BURLINGTON DEVELOPMENT REVIEW BOARD Tuesday May 19 2015 PUBLIC HEARING NOTICE

BURLINGTON DEVELOPMENT REVIEW BOARD Tuesday, May 19, 5:00 p.m. Contois Auditorium, City Hall, 149 Church Street, Burlington, VT AGENDA

To: Development Review Board
From: Mary O'Neil, AICP, Senior Planner
Date: May 19, 2015
RE: 54 Muirfield Drive, ZP15-1039CA/HO

JOB MEMO: 451 & 465 Appletree Point Road
RE: DRB & DAB Application Submittal
DATE: March 26, 2015
TO: Scott Gustin, Burlington Planning and Zoning
FROM: Brad Rabinowitz

Landscape and Planting Plan

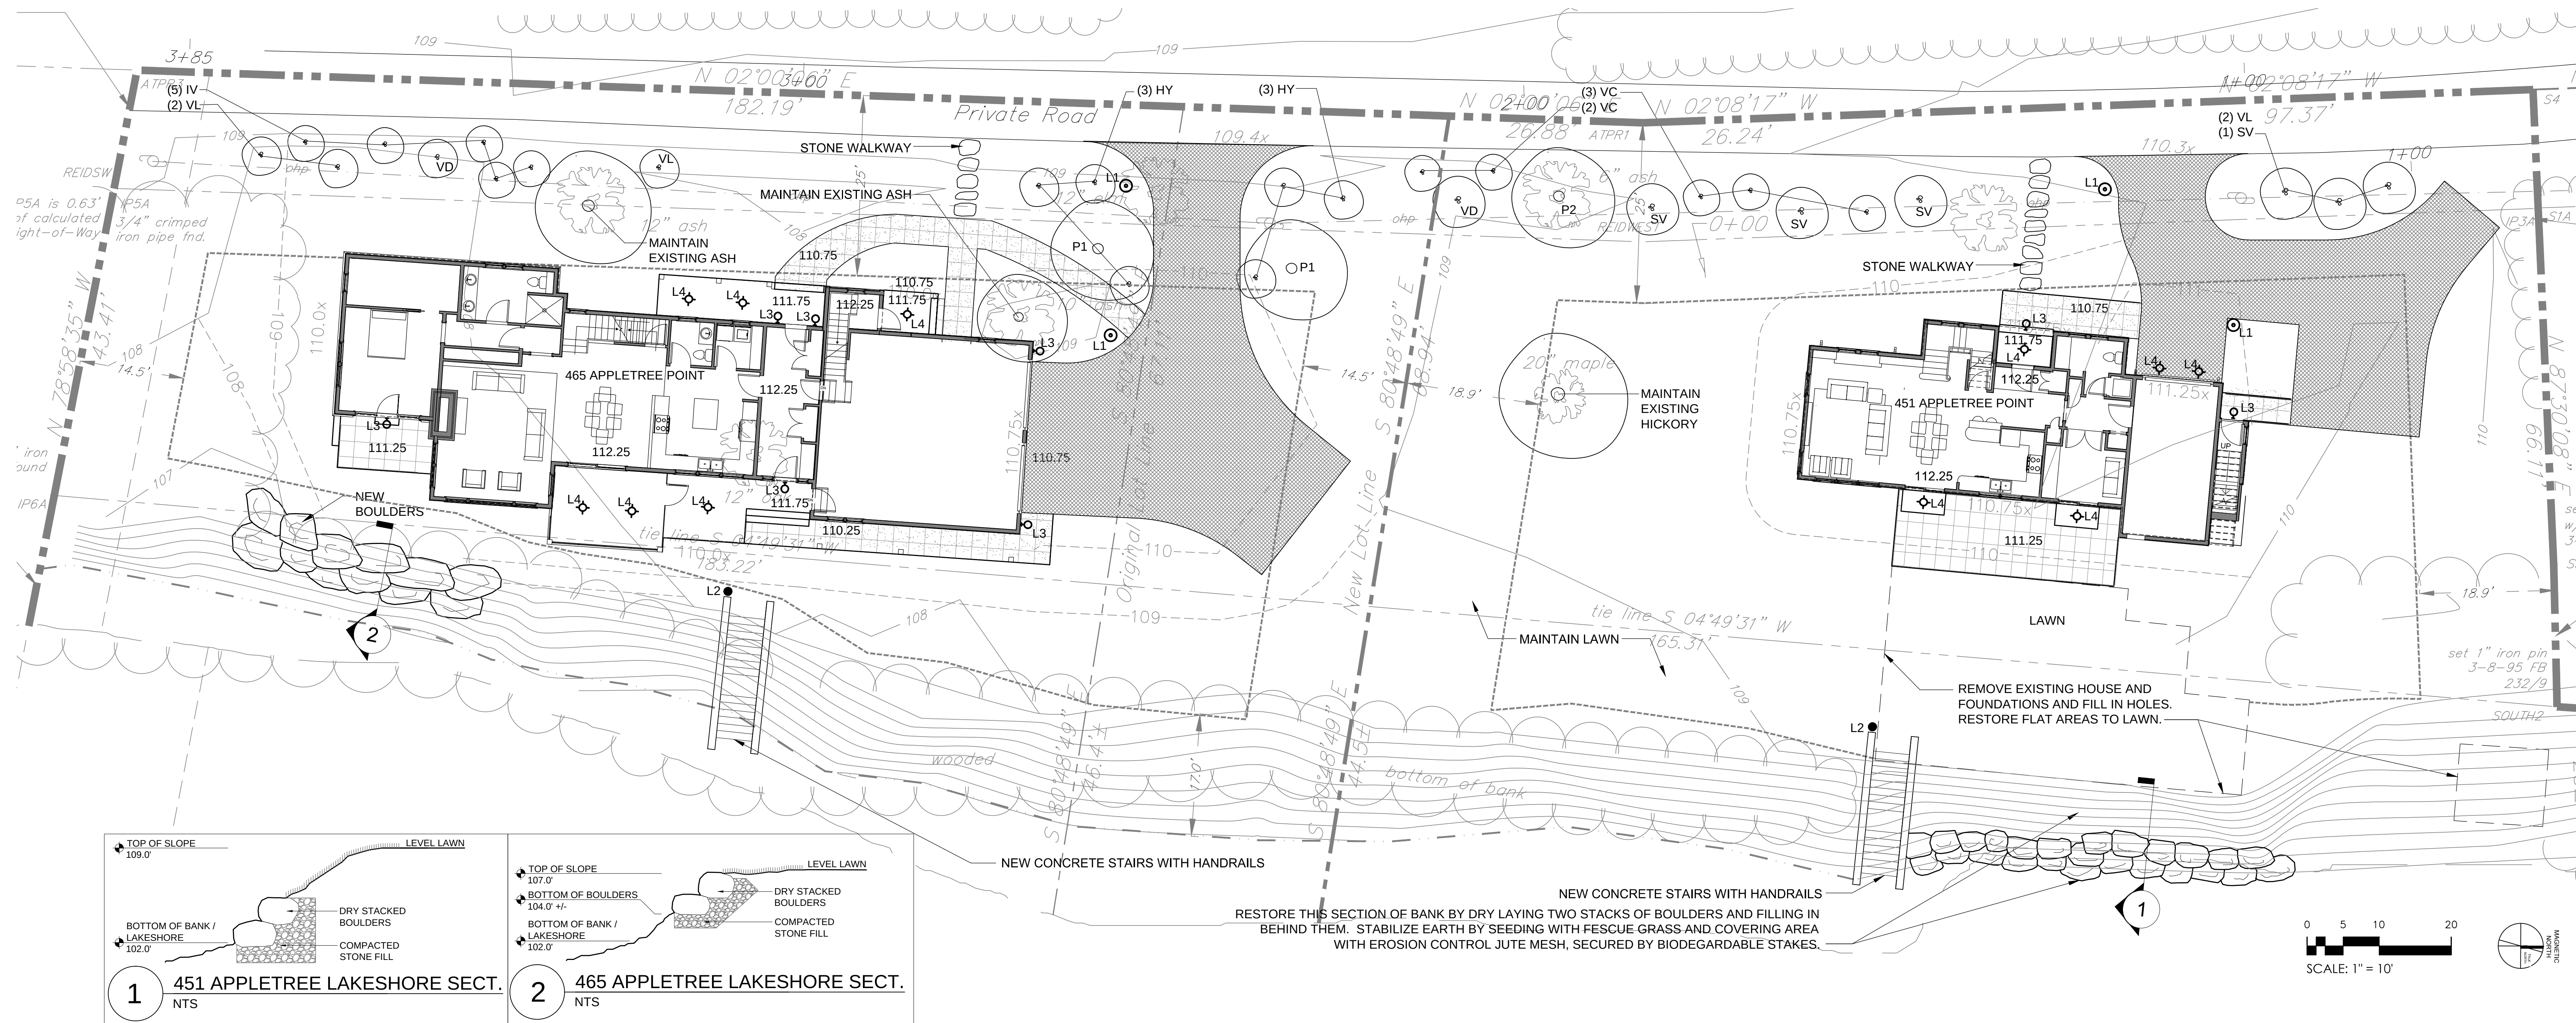
This lakeshore site is lightly wooded. Most of the trees are concentrated along the shoreline. Some tree removal is proposed as noted on the landscape and planting plan; however, a number of the existing trees will remain. The lakeshore itself is a significant natural feature and is protected by the riparian and littoral conservation zone. This overlay limits tree clearing and also requires stormwater management. The stormwater management plan has been reviewed and approved by the Conservation Board and the Stormwater Administrator. **(Affirmative finding)**

Clearing limits are depicted. Much of the existing vegetation will be retained. New landscaping is proposed and consists of a variety of shrubs and one new peach tree. Much of the new landscaping is proposed along the roadside and will provide some buffering between the new home and the road. No new fencing is proposed; however, a boulder wall will be installed to help shore up the slope where the existing camp will be removed. Topographic information indicates the bottom of this wall will be above the 102' elevation and out of the lake's flood zone. New concrete stairs will provide access to the lakeshore. **(Affirmative finding)**

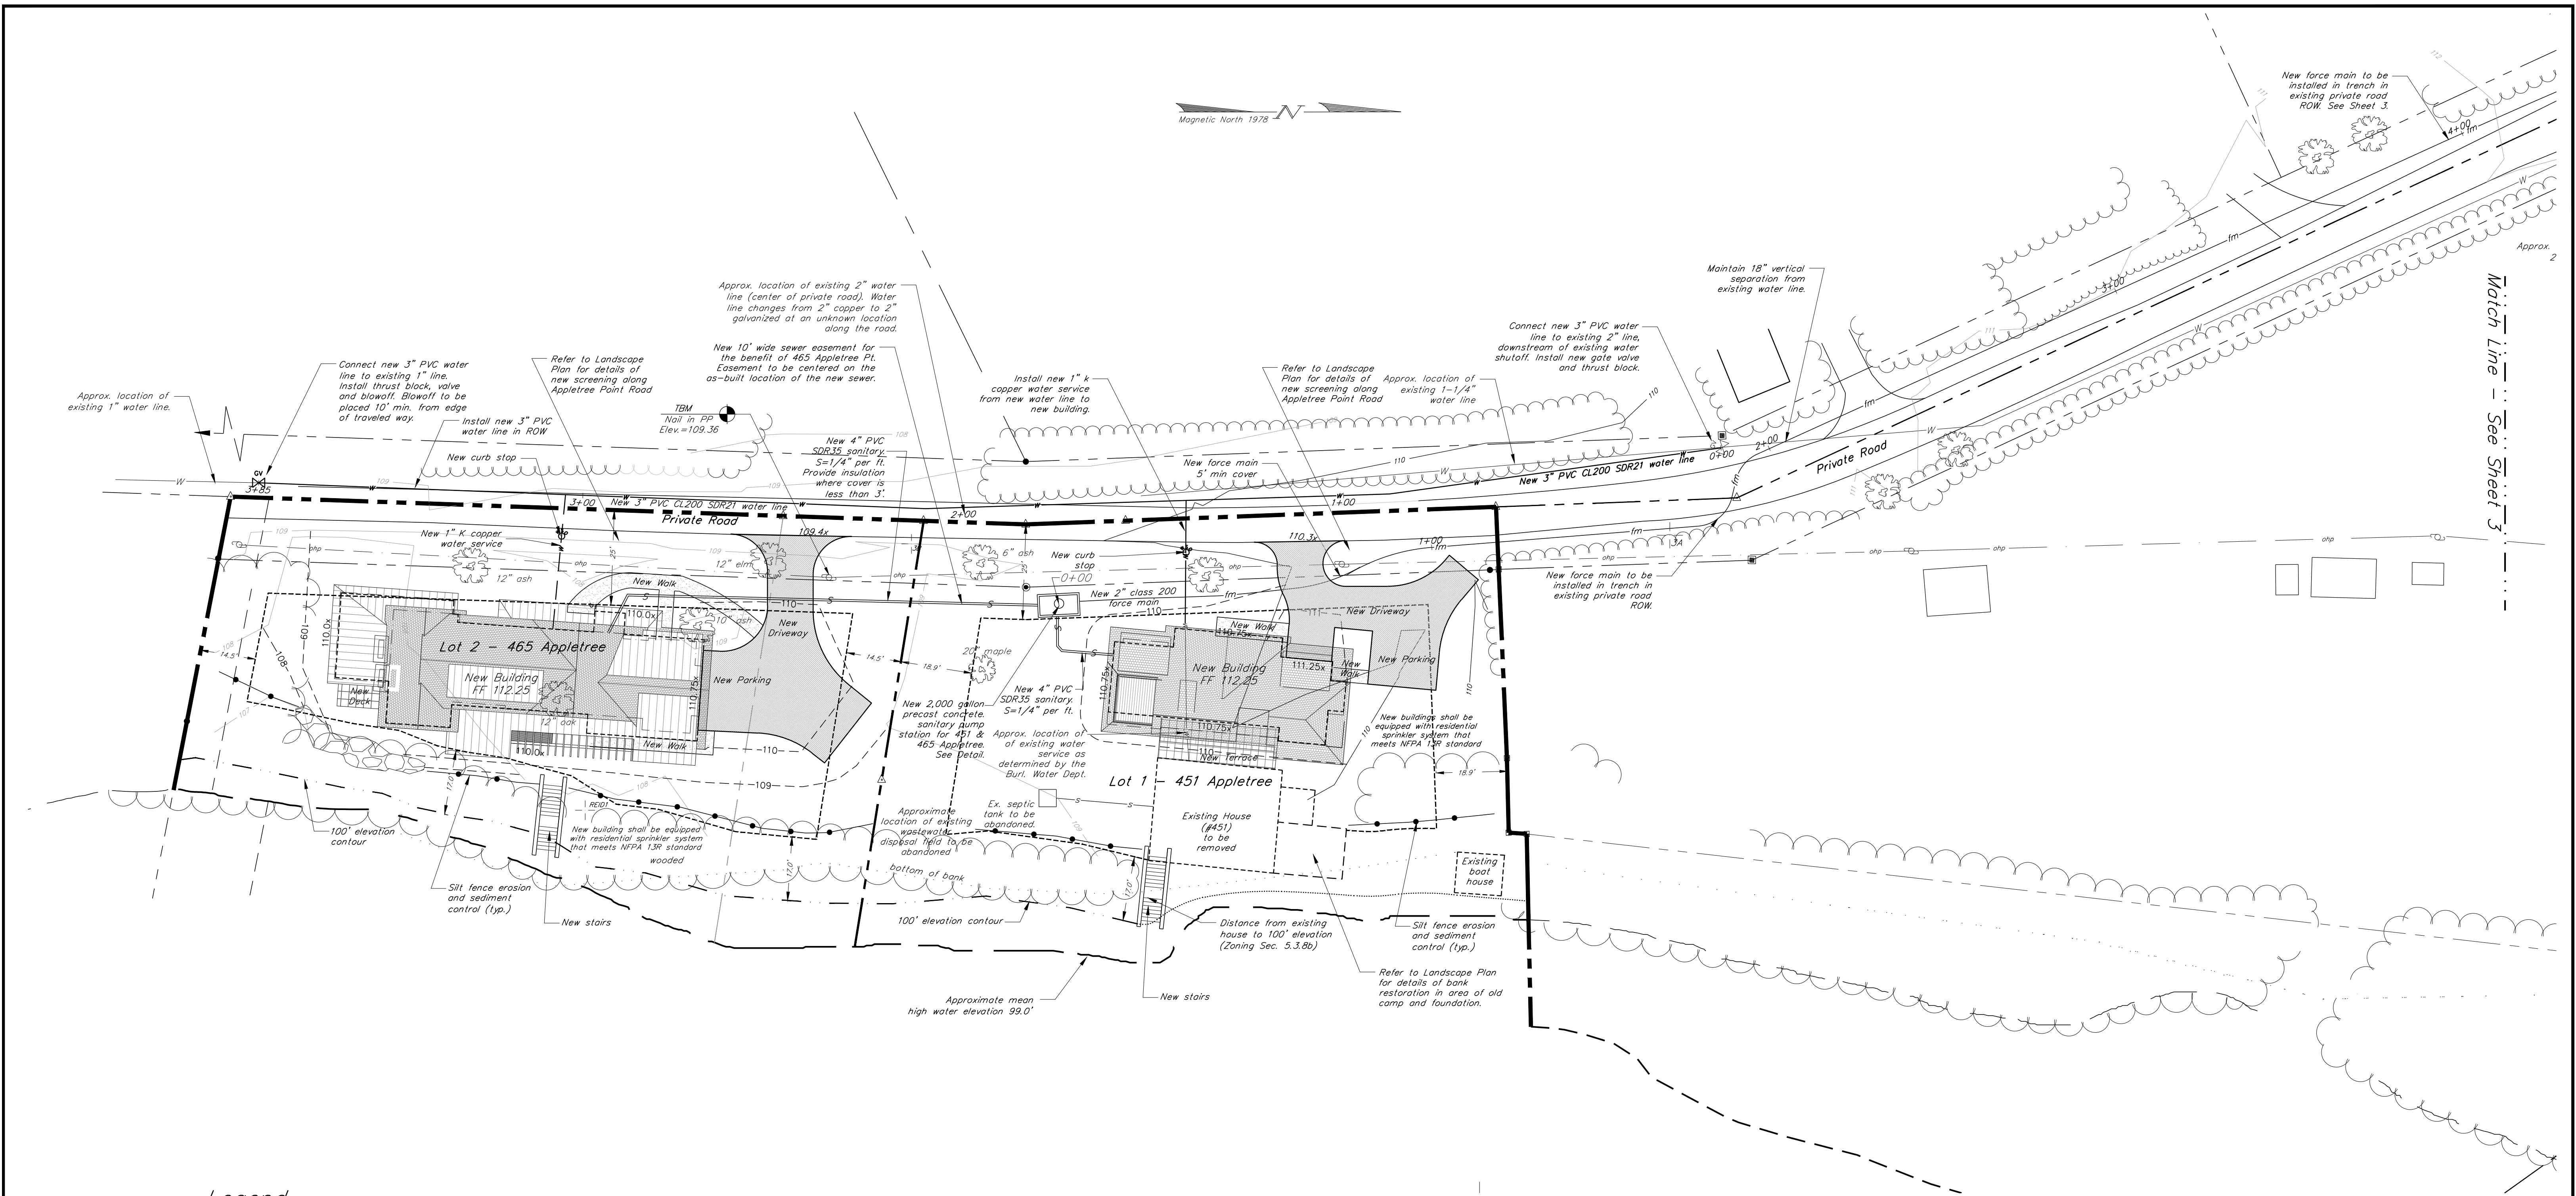
New utility lines must be buried. No mechanical equipment is depicted on the plan; however, the applicant has noted that an AC compressor will be located behind the building. This item must be depicted on the site plan. **(Affirmative finding as conditioned)**

1. **Prior to release of the zoning permit**, revised plans shall be submitted subject to staff review and approval. Revised plans shall depict:
 - a. The proposed AC compressor; and,
